# CITY OF ALBUQUERQUE

**Re: Juan Tabo Business Park**  
**1091 Juan Tabo Pl NE**  
**Traffic Circulation Layout**  
Engineer's Stamp 04-12-23 (G21-D021)

Based upon the information provided in your submittal received 04-18-23, the above referenced plan cannot be approved for Building Permit until the following comments are addressed:

**FIGURE 7.4.113 Cul-de-sac Dimensions**

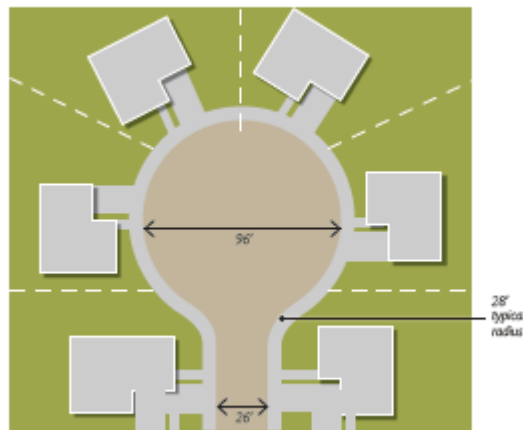
1. Identify all existing access easements and rights of way width dimensions.
2. The proposed cul-de-sac diameter does not meet current standards for a turnaround. Please see attached and follow the design guidance.

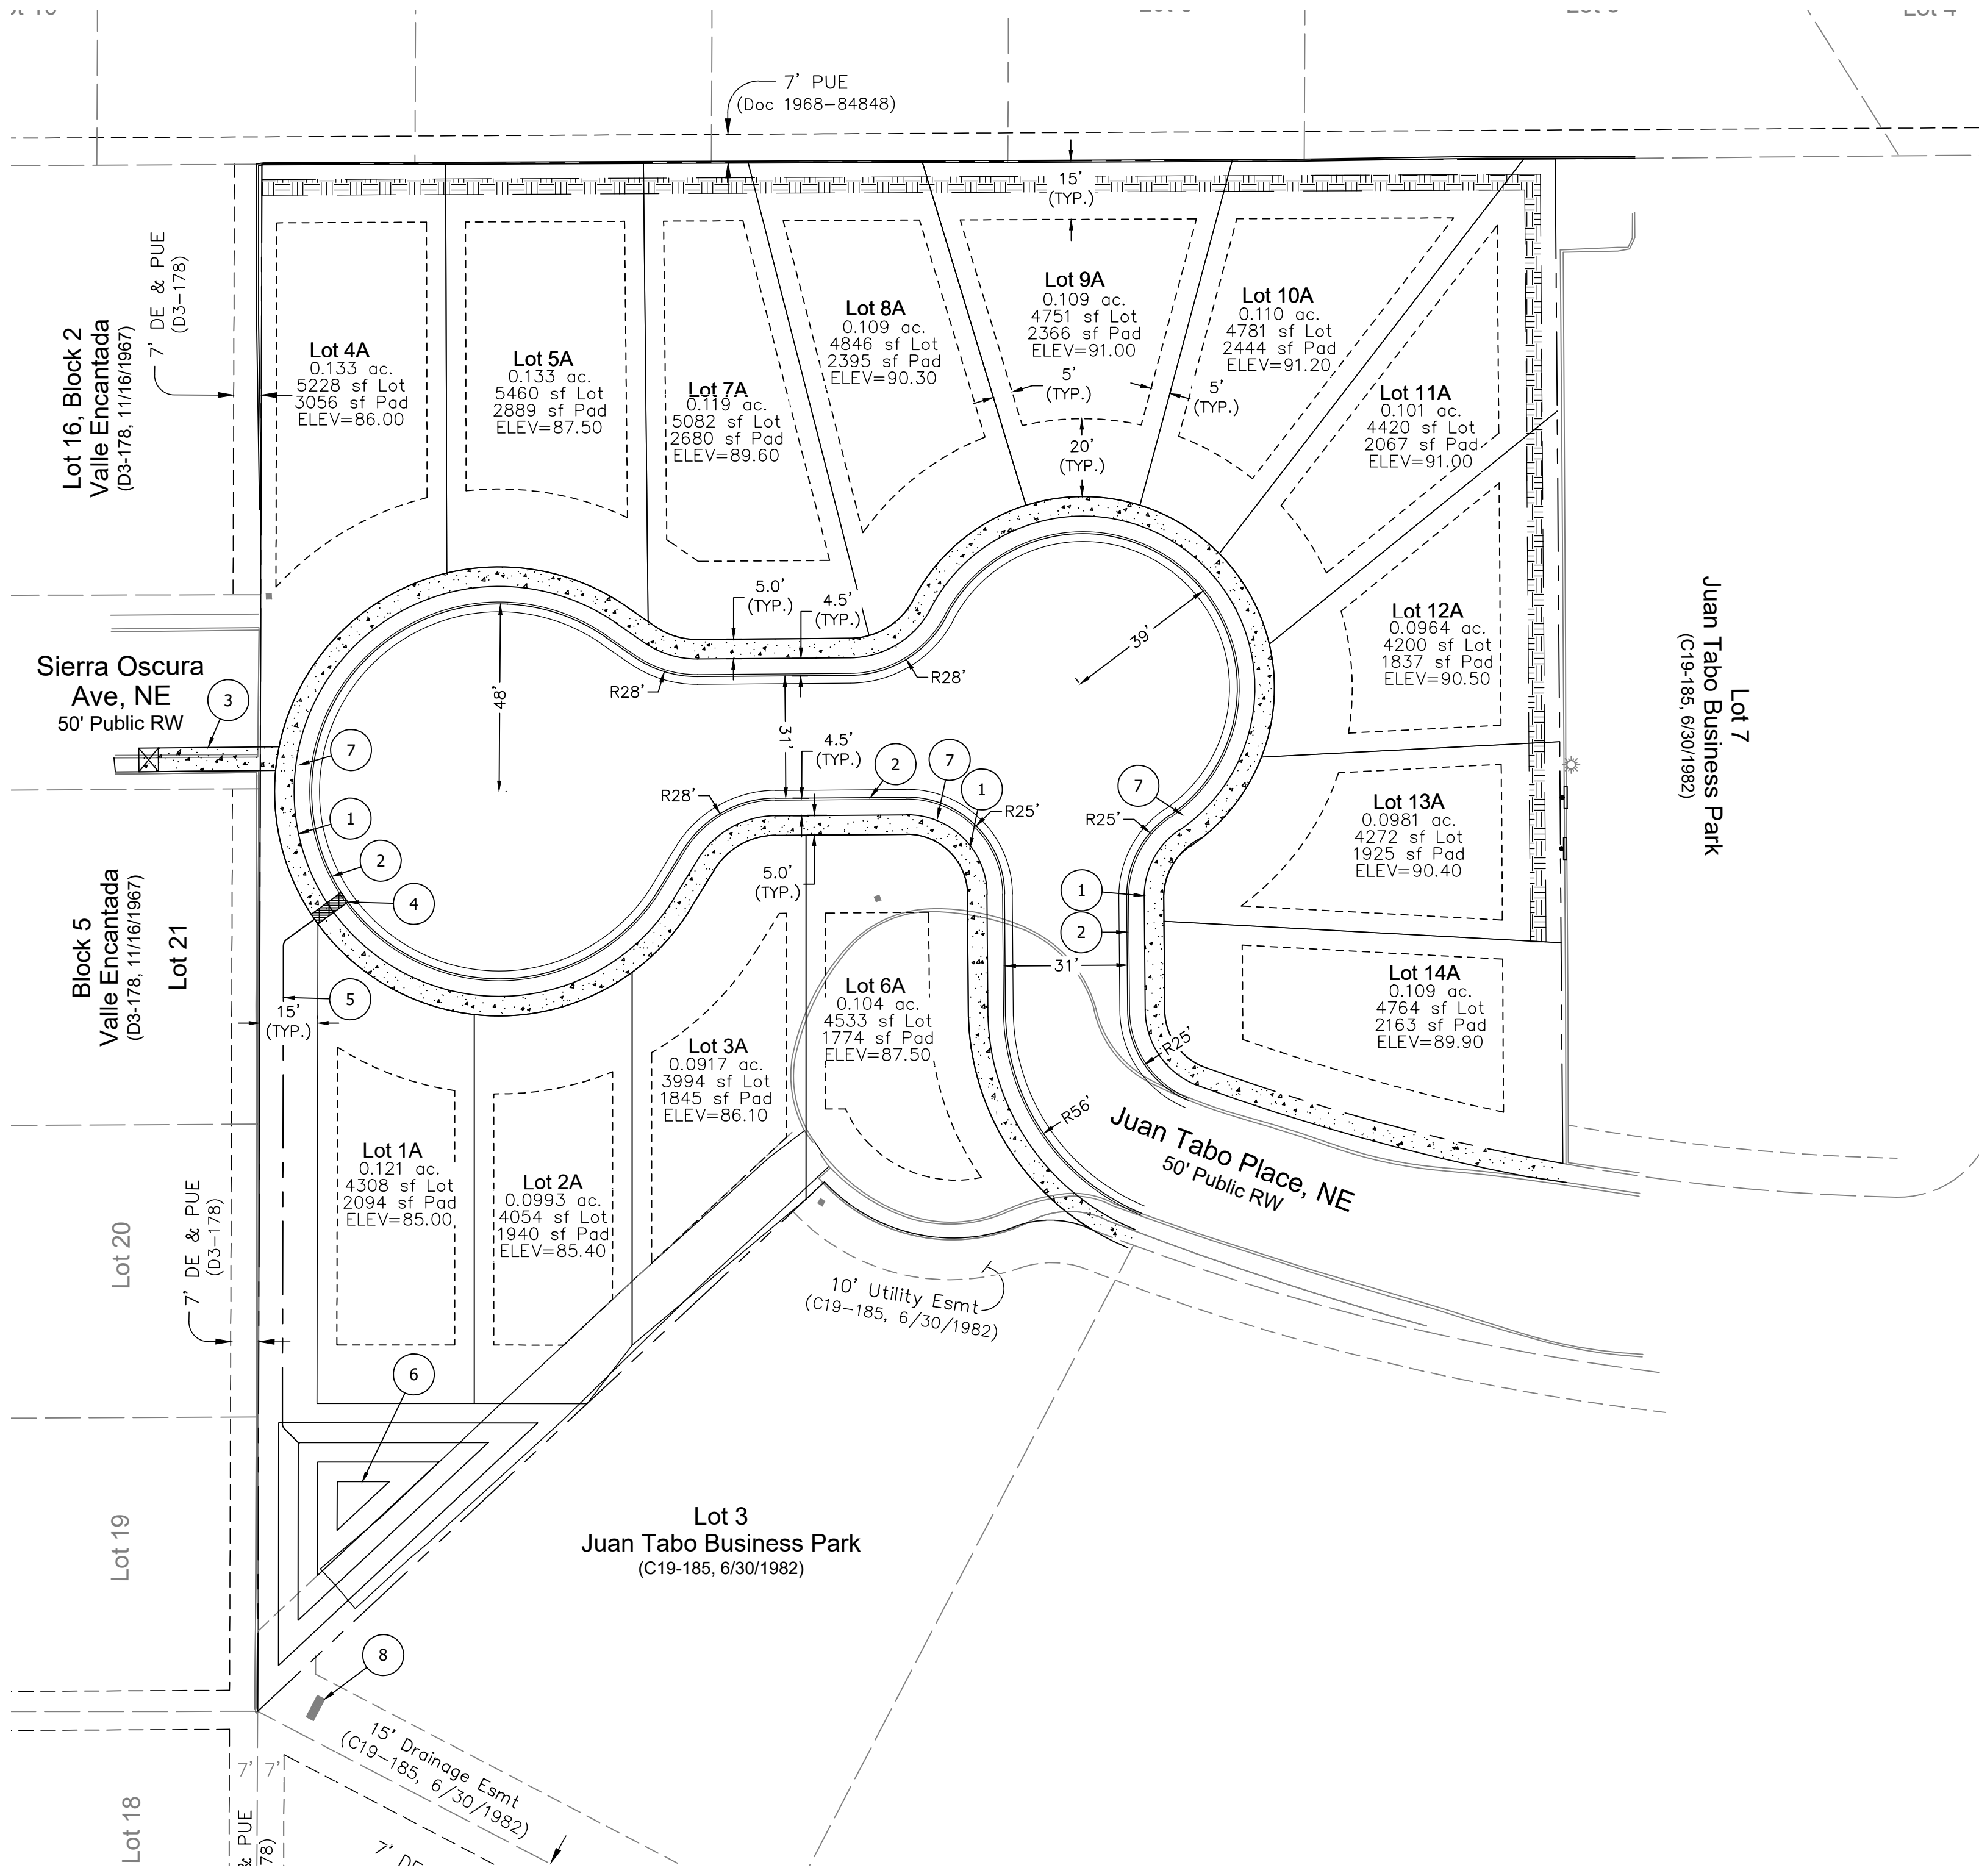
3. are the proposed
4. please provide copy of Fire Marshal and Solid Waste approval.
5. Provide copy of approved plat.
6. Please explain, is each house has a car garage? If so, please provide curb cut width and driveway design.

7. Work within the public right of way requires a work order with DRC approved plans.
8. Please add a note on the plan stating "All improvements located in the Right of Way must be included on the work order."
9. Please provide a letter of response for all comments given.
10. Traffic Studies: See the Traffic Impact Study (TIS) thresholds. In general, a minimum combination of 100 vehicles entering and exiting in the peak hour warrants a Traffic Impact Study. Visit with Traffic Engineer for determination, and fill out a TIS Form that states whether one is warranted. In some cases, a trip generation may be requested for determination (**Contact Matt Grush: [mgrush@cabq.gov](mailto:mgrush@cabq.gov)**).
